CABINET MEMBER FOR HIGHWAY MANAGEMENT – 12 OCTOBER 2023

TOWERSEY: PROPOSED 20MPH SPEED LIMITS

Report by Corporate Director, Environment and Place

Annexes Annex 1: Consultation plan

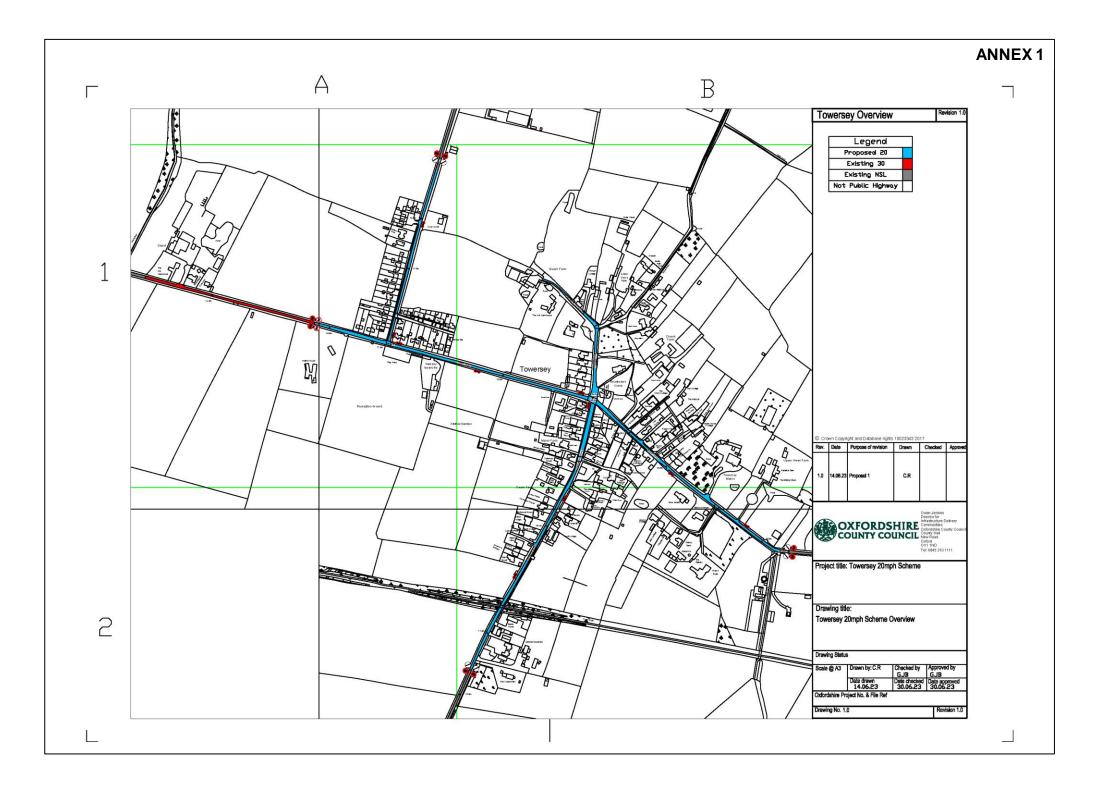
(30) Local Resident, (Towersey, Manor Road)	Concerns – I support but with the concern that the 20mph speed limit in Thame Road ought to commence at the same point as does the existing 30mph speed limit; i.e. in the vicinity of the Helpful Hirings site. Travel change: Yes – walk/wheel more

(31) Local Resident, (Towersey, Manor Road)	Concerns – I support but with the concern that the 20mph speed limit in Thame Road ought to commence at the same point as does the existing 30mph speed limit; i.e. in the vicinity of the Helpful Hirings site. Travel change: Yes – walk/wheel more

(79) Local Resident, (Towersey, Church Road)	Support – To reduce speed Travel change: Yes – walk/wheel more
(80) Local Resident, (Towersey, Lower Green)	Support – Whilst I support this proposal, I have a concern. The logic of the positioning of the 20mph limit from the Thame direction is obscure. At the current 30mph limit there are houses and the busy Helpful Hirings site. Th justifiction for keeping this at 30mph is due to traffic use, but the traffic flows are the same here as when the proposed 20mph limit is reached. This section of Thame Road is dangerous for pedestrians, cyclists and vehicle users as it is used as an acceleration zone by car users heading to Thame. Given the nature of the the traffic movements into and out of Helpful Hirings, combined with the houses the opportunity to reduce the severity of any accident here is being missed. Pleses think again about retaining this road section as a 30mph limit and incorporate into the 20mph limit, especially when many motorists currently exceed 30mph here. Travel change: Yes – walk/wheel more
